Town of Hilton Head Island

Design Review Board Meeting

Tuesday, July 22, 2025, 2:30 PM

**Food Lion
93 Matthews Drive
Plan Set
June 24, 2025
DRB-000580-2025**

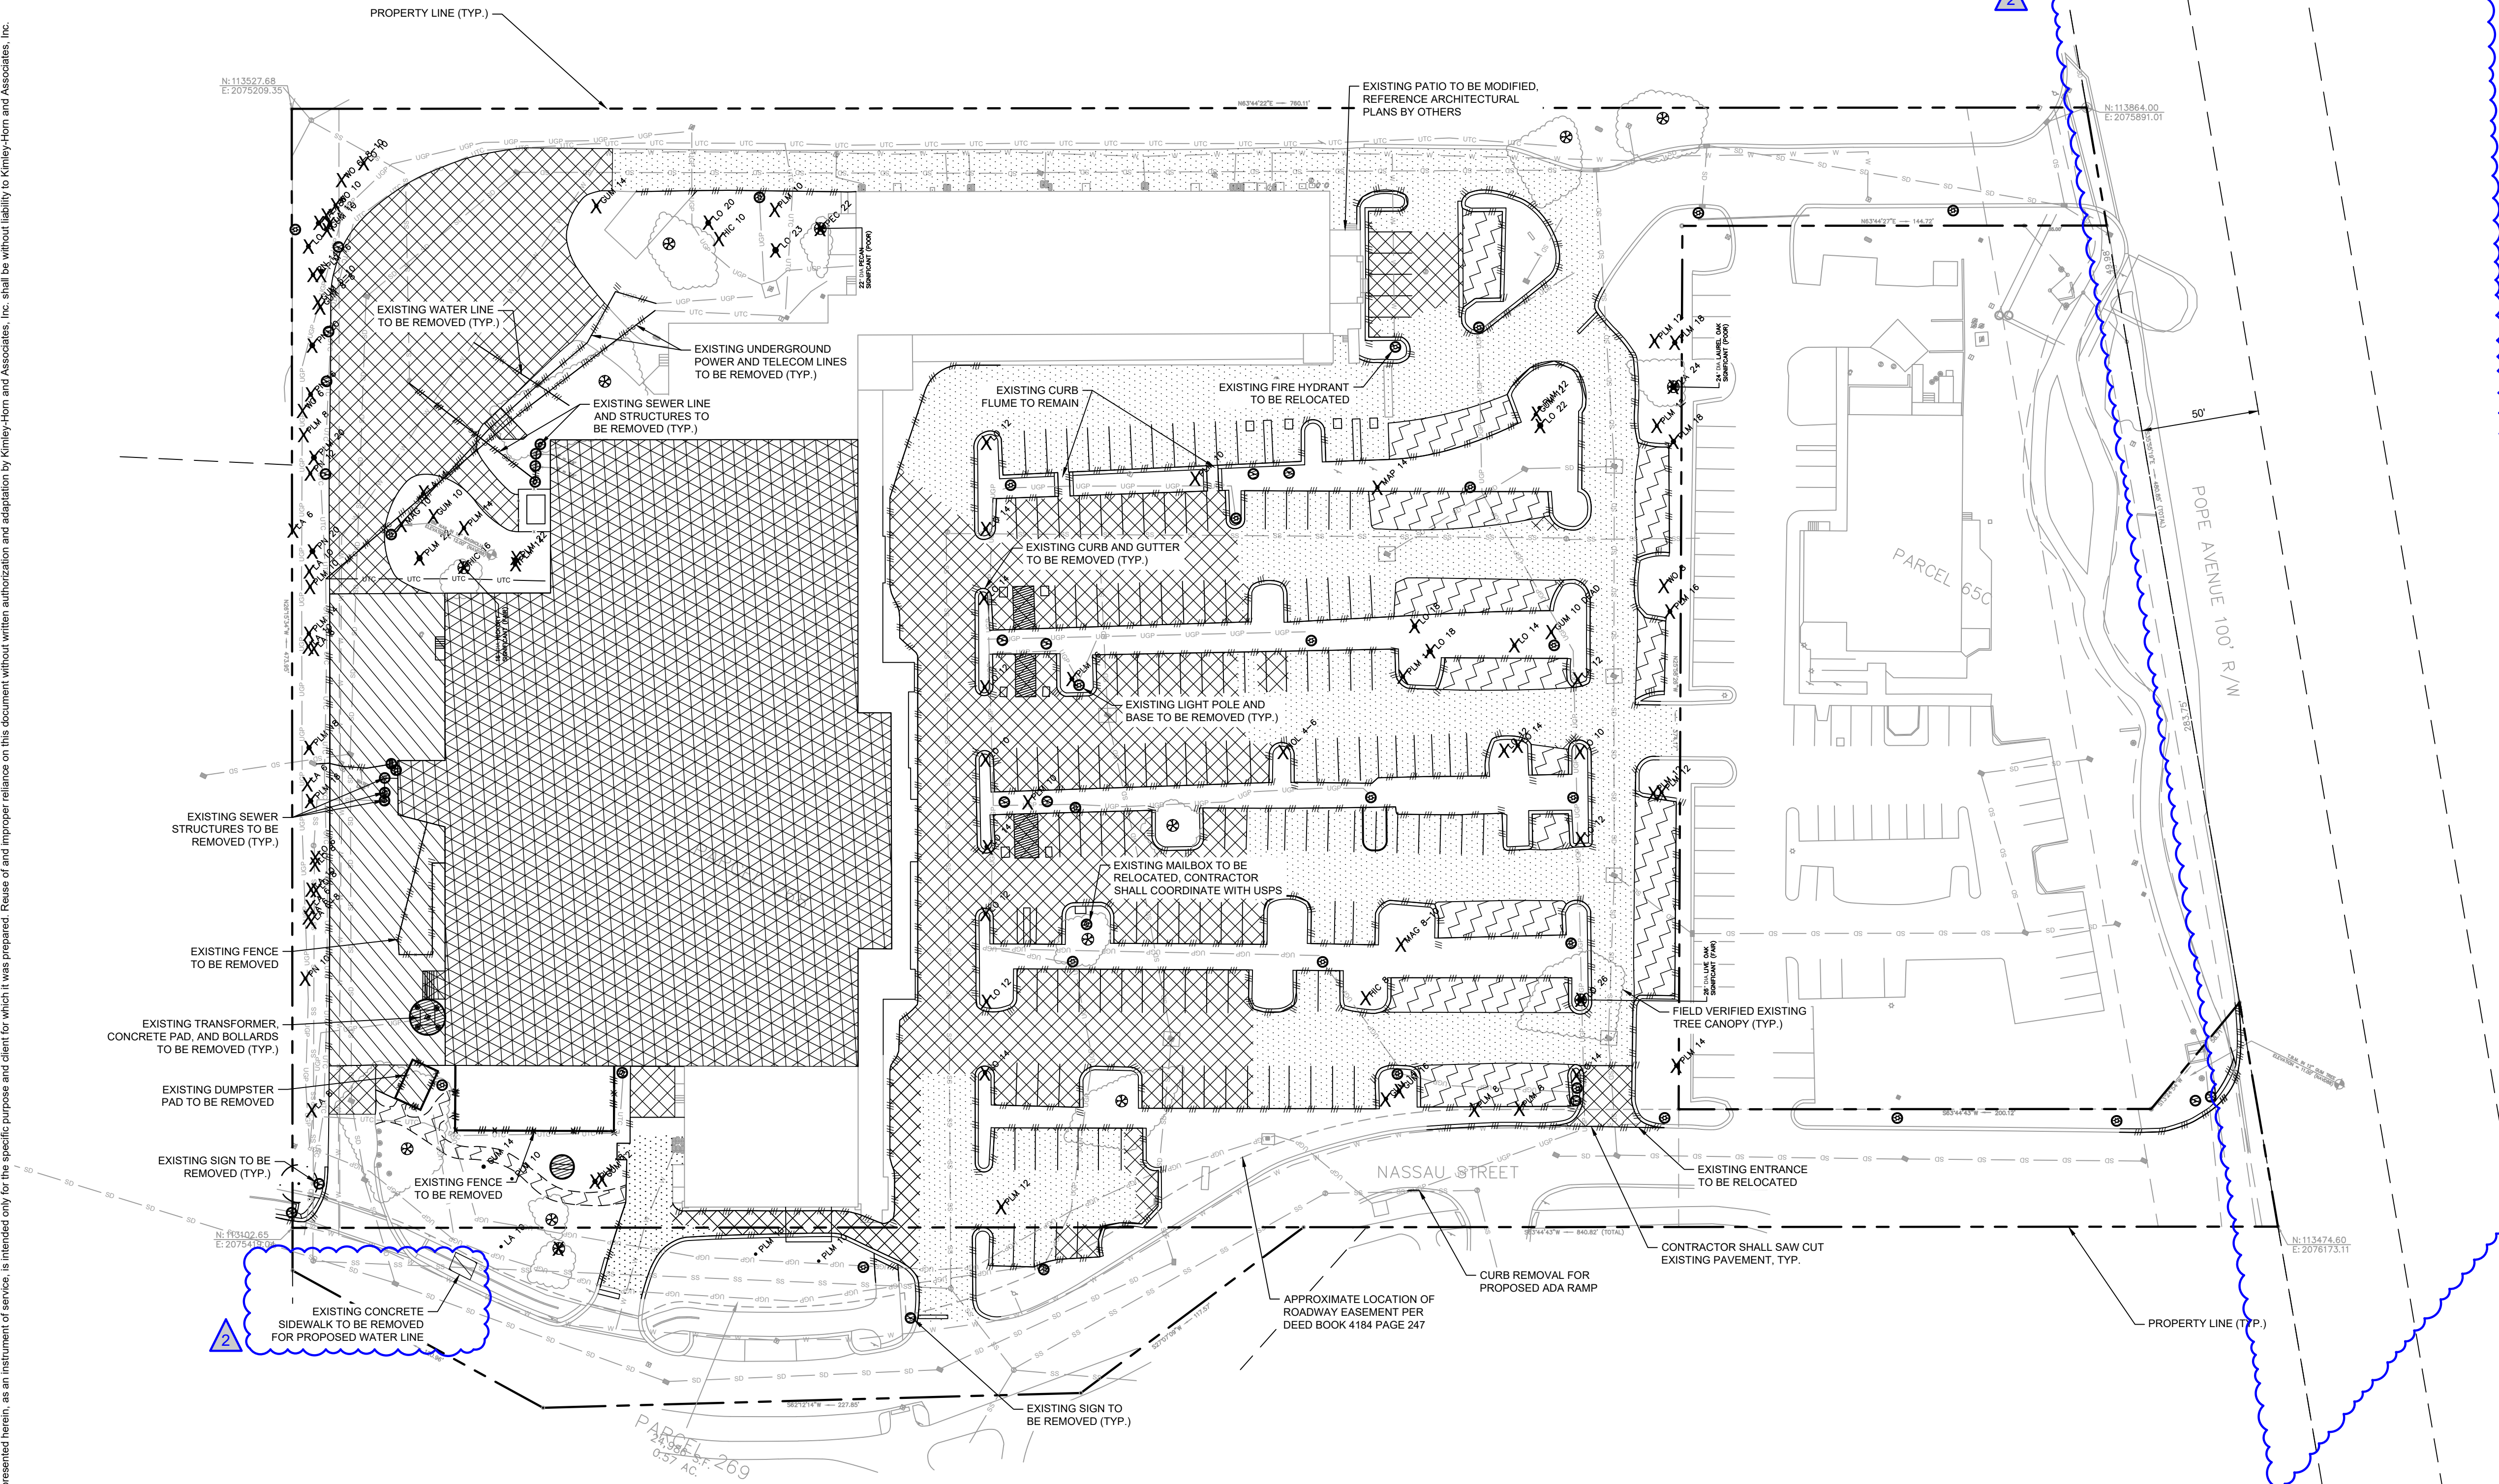
10. Need to show the entire elevation in addition to the more detailed elevations. Difficult to understand the full picture.

We have provided overall elevations on sheet PR-2.0 which include the Grocer and the shops so that you may see how they are tied together.
